ADDENDUM NUMBER TWO (2)

Project: MTK – Camp Kamassa
Kitchen/Cafeteria and Infirmary Building
4002 Sumrall Road
Crystal Springs, MS
PN: 19104

FROM: Dean Architecture, P.A.
661 Sunnybrook Road, Suite 140
Ridgeland, MS 39157
(601) 939-7717

C1.0

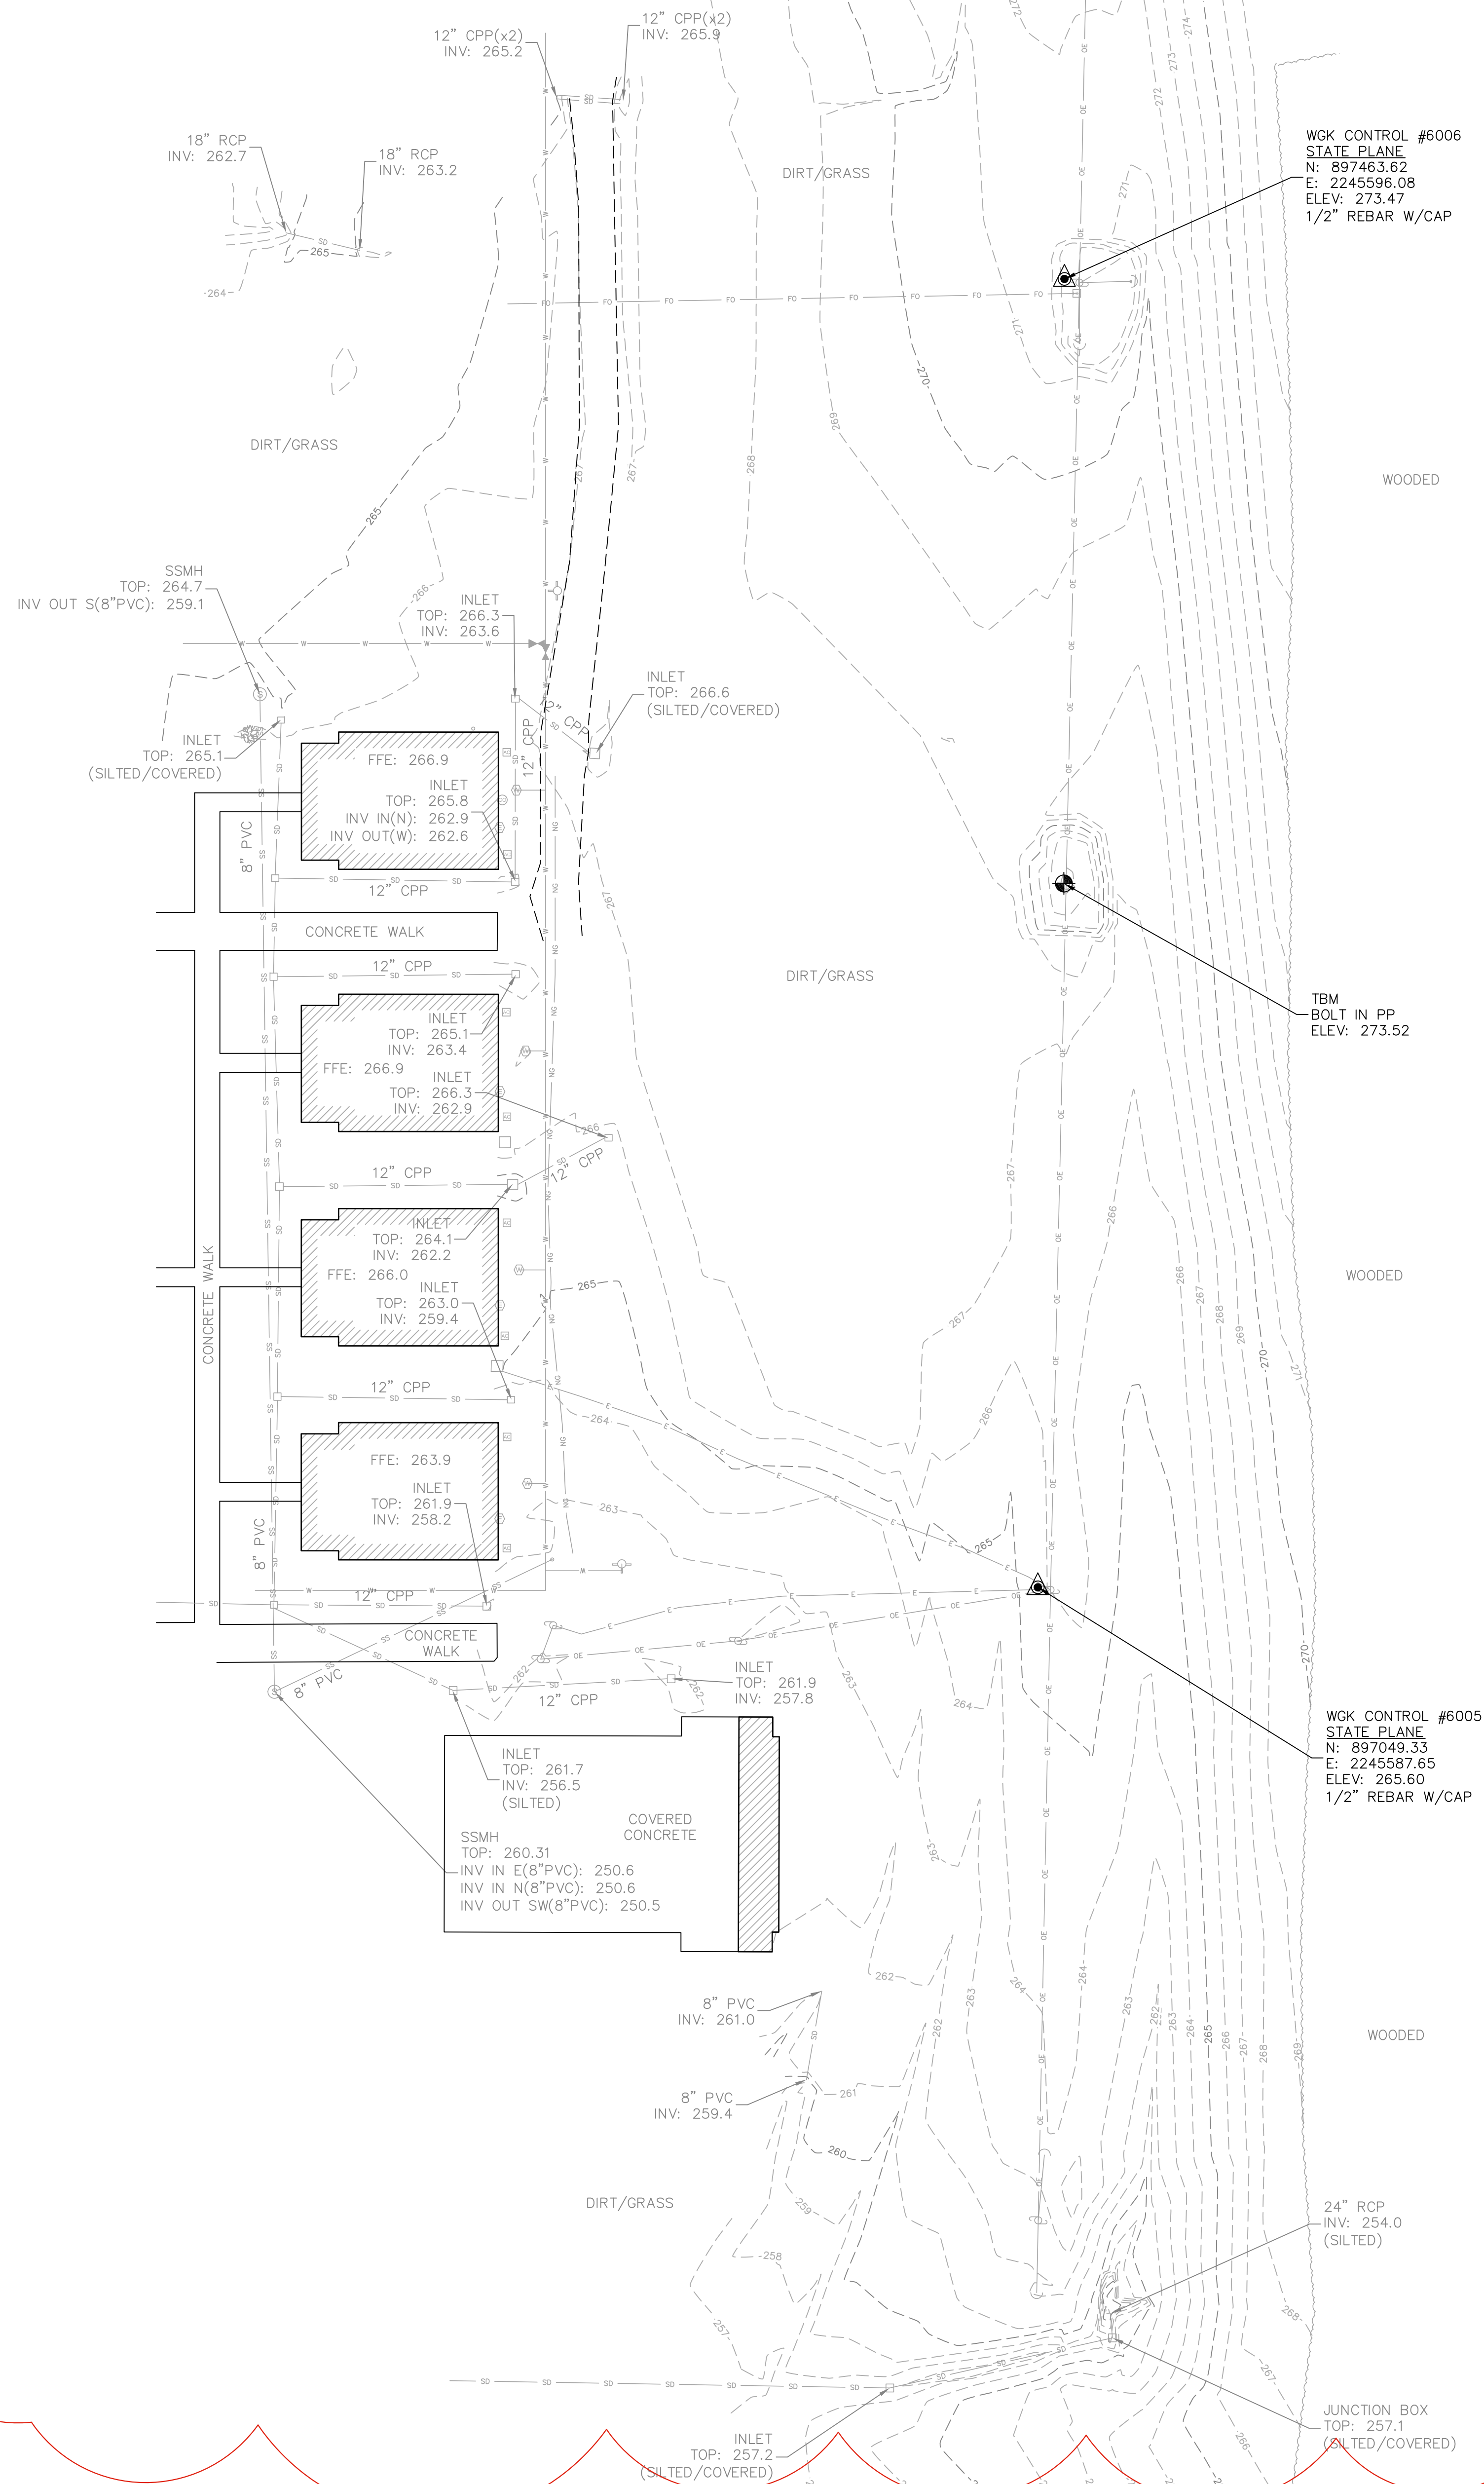
- Item #1:** Sheet C1.0 – Revised drawing index
- Item #2:** Sheet C1.1 – Added existing conditions survey sheet.
- Item #3:** Sheet C2.0 as follows:
 - Added mechanical and electrical pad information
 - Added Backflow preventer and post indicator valve locations
 - Added bollards to protect equipment
 - Added valves on water service connections
- Item #4:** Sheet C2.1 – Added this sheet for clarity on grading requirements.
- Item #5:** Sheet C3.0 – Added two additional details.
- Item #6:** Sheet C3.2 – Modified typical service assembly detail.
- Item #7:** Sheet C4.0 – Modified sheet to account for additional grading

WET AND DRY SYSTEM RISER *SCHEMATIC DETAIL*

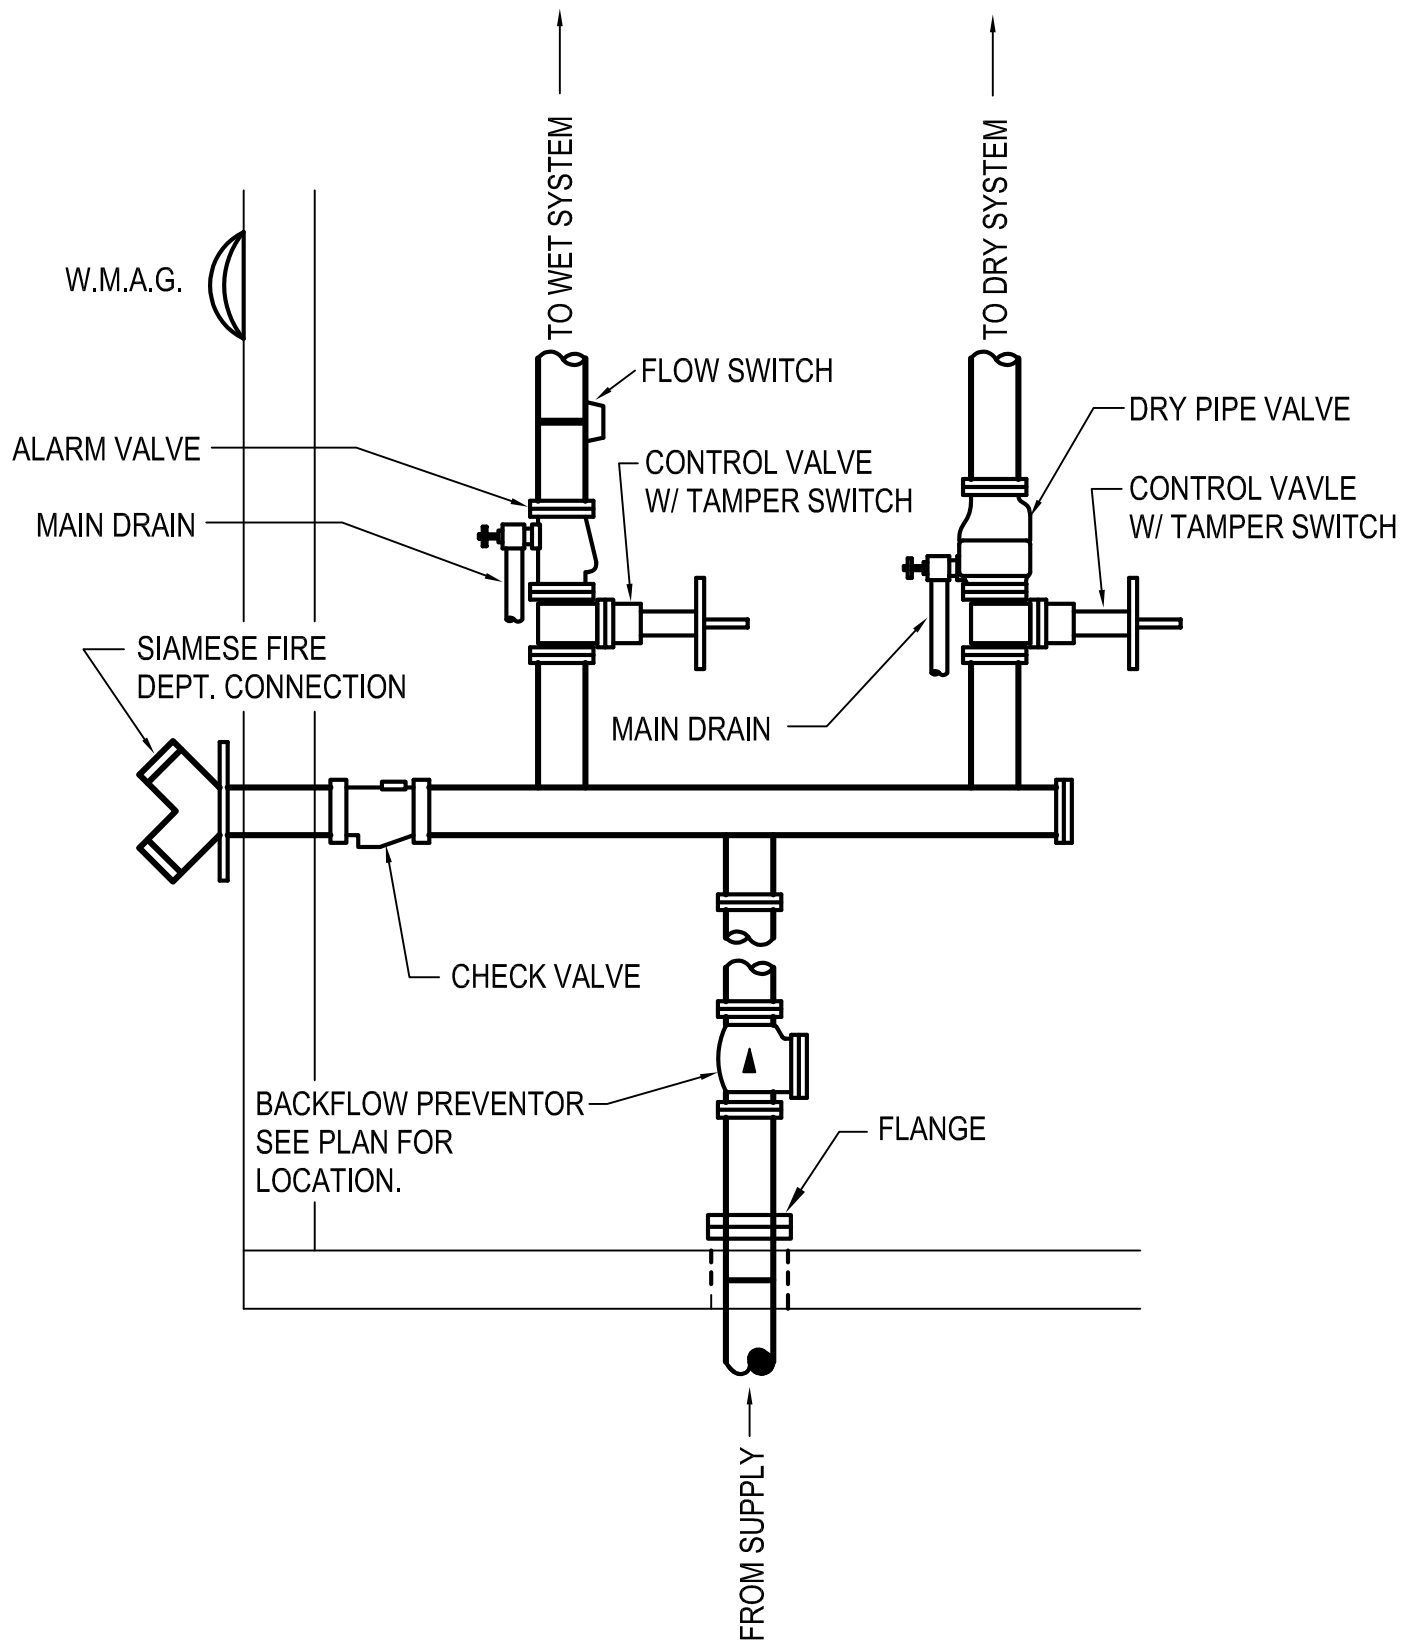
- a) Mechanical 114: Change the Fire Riser from a Dry Pipe Riser to a Wet and Dry Pipe Riser.
- b) Change all sprinkler system in Kitchen/Cafeteria from Dry Pipe to Wet Pipe.
- c) Extend 4" Dry Pipe Riser main piping from Dry Pipe Riser to the Dry Pipe main Piping located above Women's Restroom 104 ceiling and connect before it exits the Kitchen/Cafeteria building and extends to the Breezeway 100 and the entire Infirmary building.

Item No. 4: Drawings, Sheet M301: Remove the Fire Riser Detail and replace with the attached Fire Riser Detail.
